Access Compliance Report

Public Rights-of-Way

Intersection ID: 50587	Main Street: DOWNY_BIRCH_RD	Cross Street: GREAT_LAUREL_RD	Location: NE
ADA ID: A594F1C21311	Ramp Type: BlendTrans1	Initial Pass/Fail: Fail	Overall Compliance: No
			Severity Score: 21.25

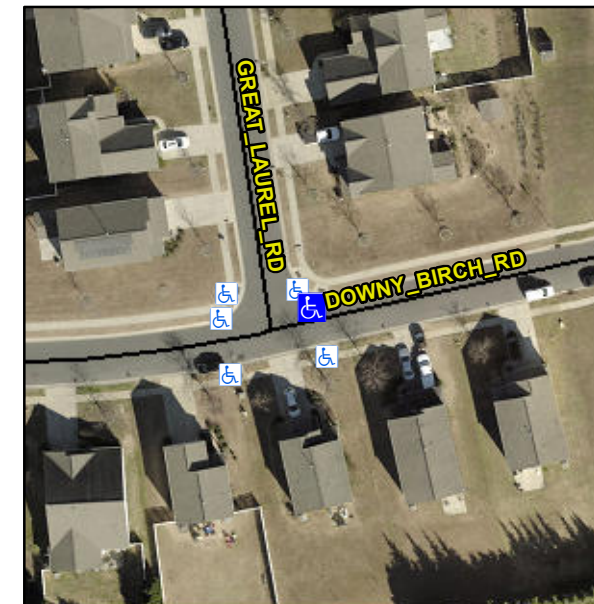
Not Found, R304.5.1, R304.5.3

Compliance	Description	Data	Compliance	Description	Data
N/A	Ramp Length (in)	48.0	Yes	BlendTrans Slope (%)	4.2
No	Ramp Width (in)	45.0	No	BlendTrans XSlope (%)	5.1
N/A	Flare Type LT	N/A	N/A	Flare Type RT	N/A
N/A	Flare Slope LT (%)	N/A	N/A	Flare Slope RT (%)	N/A
N/A	Flare Traversable LT?	N/A	N/A	Flare Traversable RT?	N/A
N/A	Landing Length (in)	N/A	N/A	DWS Provided?	N/A
N/A	Landing Width (in)	N/A	N/A	DWS Contrast?	N/A
N/A	Landing Slope (%)	N/A	N/A	DWS Length (in)	N/A
N/A	Landing X Slope (%)	N/A	N/A	DWS Full Width?	N/A
N/A	Landing Curb? (Y/N)	N/A	N/A	DWS Offset (in)	N/A
N/A	Shared Landing?	N/A			
N/A	Gutter Ponding?	N/A	N/A	Gutter Slope (%)	N/A
N/A	Gutter Lip Ht (in)	N/A	N/A	Gutter X Slope (%)	N/A
N/A	Painted X Walk1?	No	N/A	Painted X Walk2?	N/A
	X Walk 1 Direction	To S		X Walk 2 Direction	N/A
	X Walk 1 Width (in)	N/A		X Walk 2 Width (in)	N/A
	X Walk 1 Slope (%)	3.6		X Walk 2 Slope (%)	N/A
	X Walk 1 X Slope (%)	2.3		X Walk 2 X Slope (%)	N/A

N/A	Ramp inside XWalk1?	N/A	N/A	Ramp inside XWalk2?	N/A
	Road Slope (%)	2.3		Clear Space?	N/A
	Road X Slope (%)	3.6	N/A	Clear Space to XWalk (in)	N/A
N/A	Any Obstructions?	N/A	N/A	Storm Grate/Utility Hazard?	N/A
	Obstruction Type			Storm Grate/Utility Type	
		N/A			N/A
			Yes	Surface Condition? (G/P)	Good
			No	Curb Slope (%)	10.2

Remove & Replace Curb Ramp With Two New Directional Ramps or Equivalent.
